TSB150105

New Aftertreatment Selective Catalyst Reduction (SCR) Catalyst Part Numbers

This document announces new aftertreatment Selective Catalyst Reduction (SCR) catalyst part numbers and supporting parts.

Figure 4, Right-hand Vertical SCR (left) / Right-hand Horizontal SCR (right)

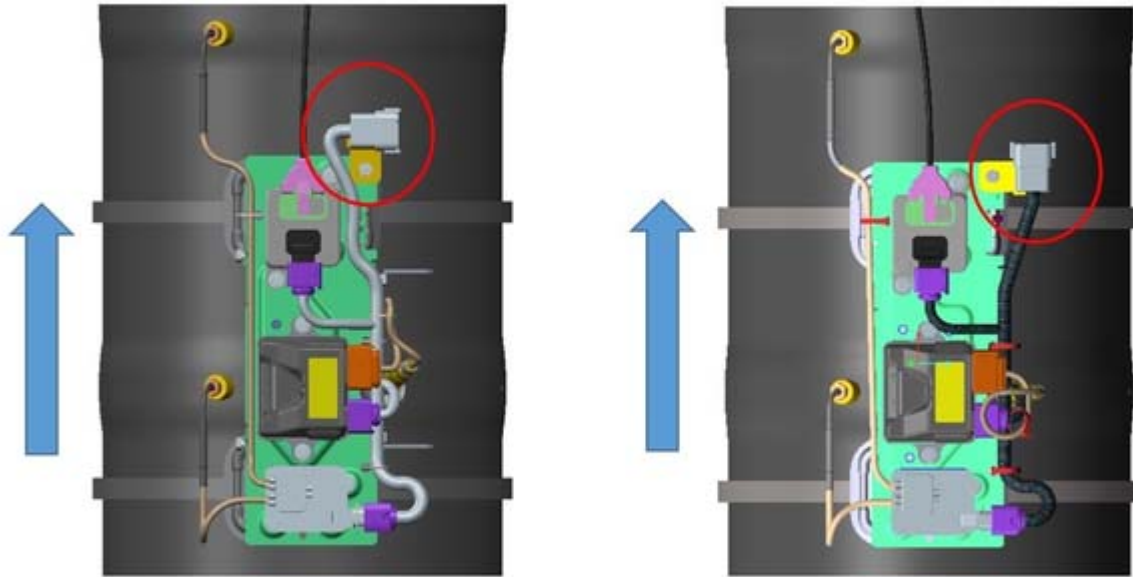
- Figures 4 and 5 provide images to differentiate between the different SCR configurations when determining what engine harness to use.
- The horizontal and vertical nomenclature describes the orientation of how the SCR is installed in the equipment. The OEM wiring harness connectors are circled in the images; direction of exhaust flow is shown by the arrows.
